**ORDNANCE AND EXPLOSIVES
ENGINEERING EVALUATION/
COST ANALYSIS REPORT – RESPONSE TO
COMMENTS**

**SENECA ARMY DEPOT
ROMULUS, SENECA COUNTY, NEW YORK**

**SENECA ARMY DEPOT ACTIVITY
and
U.S. ARMY CORPS OF ENGINEERS
NEW YORK DISTRICT
and
HUNTSVILLE CENTER**

Figure 9.7
Proposed Areas of Clearance
SEAD-45 (Open Detonation Area)

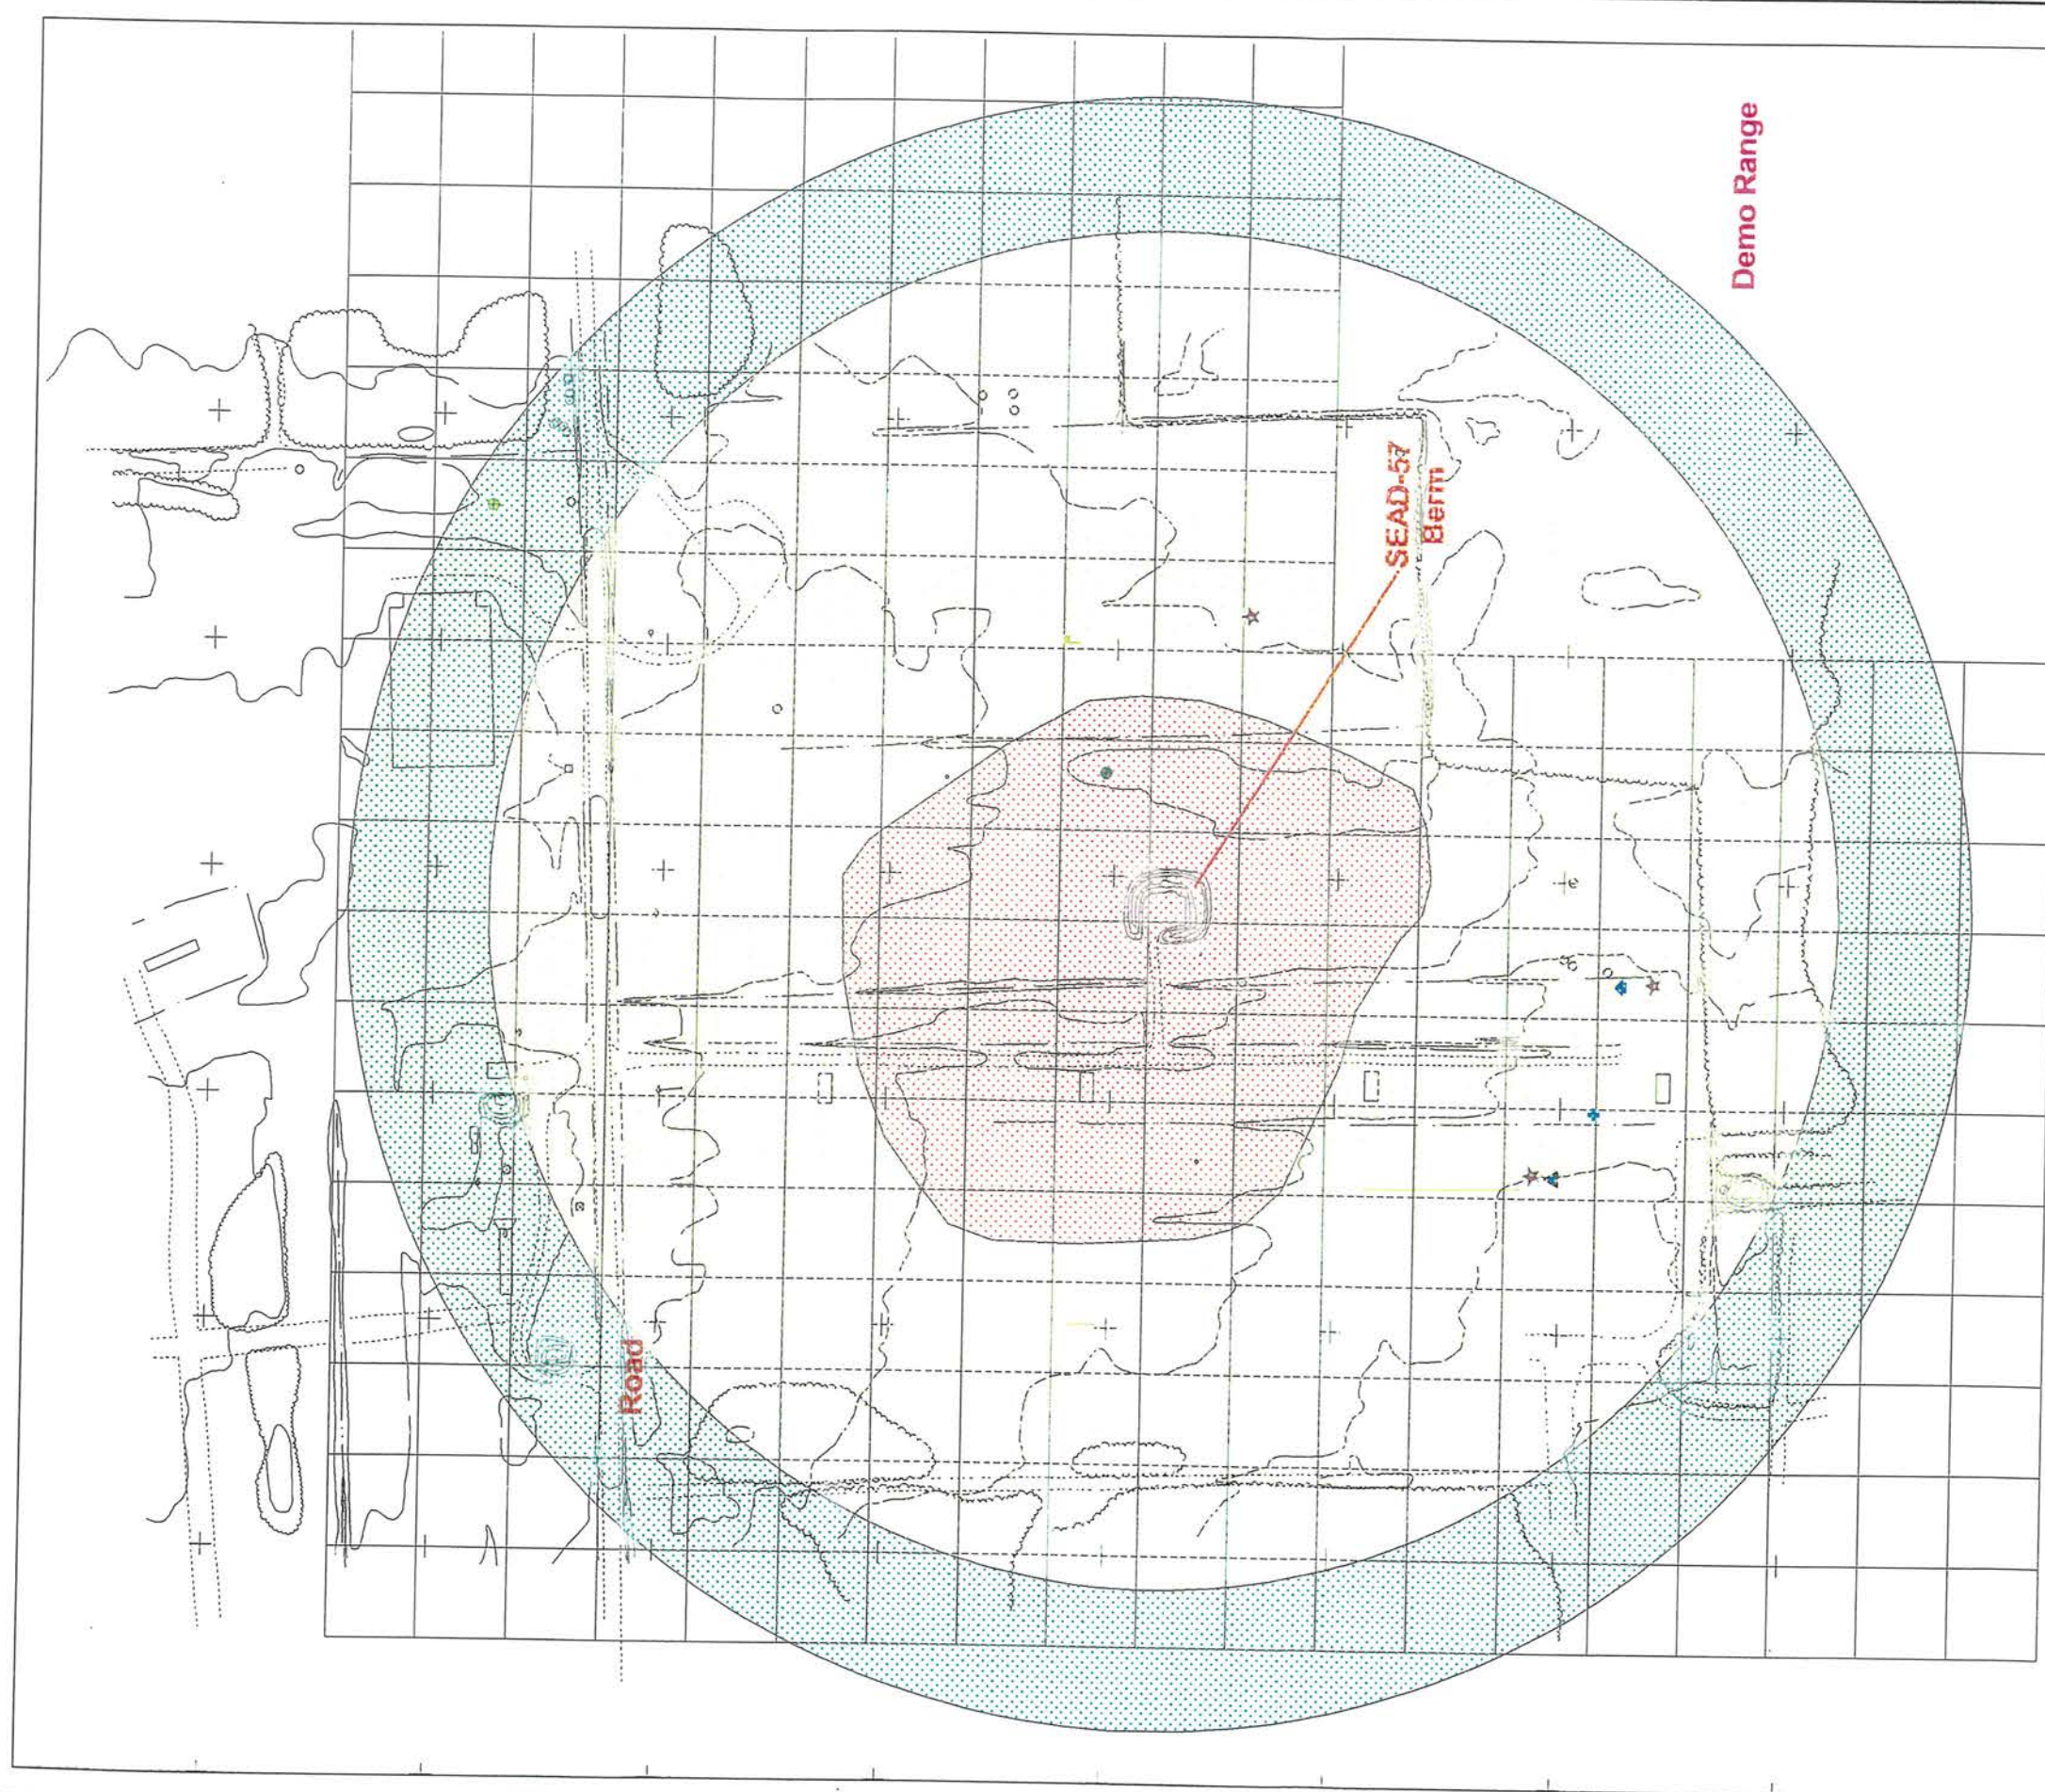
21. **Figure 3.32.** This figure provides the investigation area for SEAD-45, which includes a 1,800-foot radius around the demolition berm to the north and west. The text should explain why the investigation radius was not extended to completely surround the berm.

9.2.4.2 The recommended response action in SEAD-45 includes the removal, sifting, replacement, and restoration of 255,000 cubic yards of soil. This estimate assumes excavation of 70 acres to a depth of 2 feet, as shown in red on Figure 9.7. Also, the existing demolition berm is included in the total volume of soil to be sifted. After the material is removed, the recommended response action includes 100% confirmation sampling in this area to assure the complete removal of residual OE/UXO. Outside of the excavated area, a total of 220 acres of geophysics will be performed out to a distance of 2000 feet from the Demolition Berm. This includes all of the area outside of the excavated section as very few grids were completely investigated intrusively during the EE/CA. The Clearance to Depth of 6 Inches Alternative is recommended for the 160 acres between the 2000-foot radius and 2500-foot radius from the Demolition Berm. The approximate areas over which each type of operation should be performed are shown on Figure 9.1.
